ADA Curb Ramp New Construction Inspection Form (Perpendicular)

NW Glencoe Rd

24952.54

NW McKay Creek Ct

PERPENDICULAR RAMP (PR)

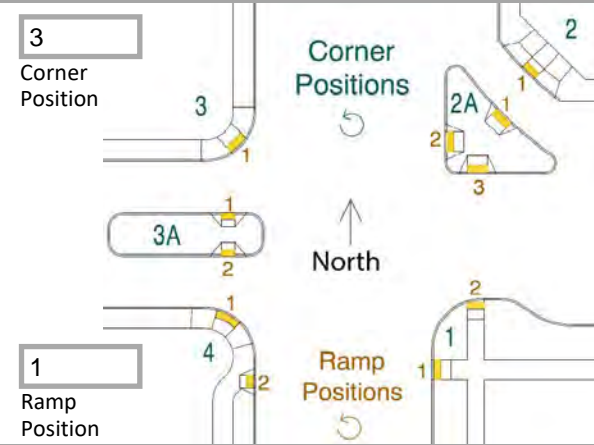
Crack in curb and gutter
